Access Compliance Report

Public Rights-of-Way

Intersection ID: 3145	Main Street: BASKERVILLE_AV	Cross Street: PALLADIUM_PL	Location: S
ADA ID: EFF7BC50E8BA	Ramp Type: Perp	Initial Pass/Fail: Fail	Overall Compliance: No
Severity Score: 12.5			
Codes/Mitigation Info/Possible Solution		Field Measurements/Component Compliance

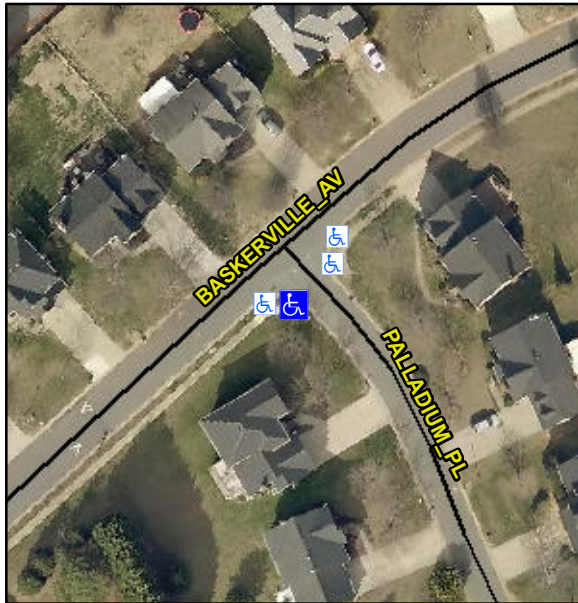
Not Found, R304.2.2

Compliance	Description	Data	Compliance	Description	Data
N/A	Ramp Length (in)	44.0	No	Ramp Slope (%)	9.1
Yes	Ramp Width (in)	67.0	Yes	Ramp XSlope (%)	0.5
N/A	Flare Type LT	N/A	N/A	Flare Type RT	N/A
N/A	Flare Slope LT (%)	N/A	N/A	Flare Slope RT (%)	N/A
N/A	Flare Traversable LT?	N/A	N/A	Flare Traversable RT?	N/A
N/A	Landing Length (in)	N/A	N/A	DWS Provided?	N/A
N/A	Landing Width (in)	N/A	N/A	DWS Contrast?	N/A
N/A	Landing Slope (%)	N/A	N/A	DWS Length (in)	N/A
N/A	Landing X Slope (%)	N/A	N/A	DWS Full Width?	N/A
N/A	Landing Curb? (Y/N)	N/A	N/A	DWS Offset (in)	N/A
N/A	Shared Landing?	N/A			
N/A	Gutter Ponding?	N/A	N/A	Gutter Slope (%)	N/A
N/A	Gutter Lip Ht (in)	N/A	N/A	Gutter X Slope (%)	N/A
N/A	Painted X Walk1?	No	N/A	Painted X Walk2?	N/A
	X Walk 1 Direction	To NE		X Walk 2 Direction	N/A
N/A	X Walk 1 Width (in)	N/A	N/A	X Walk 2 Width (in)	N/A
	X Walk 1 Slope (%)	2.2		X Walk 2 Slope (%)	N/A
	X Walk 1 X Slope (%)	0.3		X Walk 2 X Slope (%)	N/A

Remove & Replace Entire Ramp.
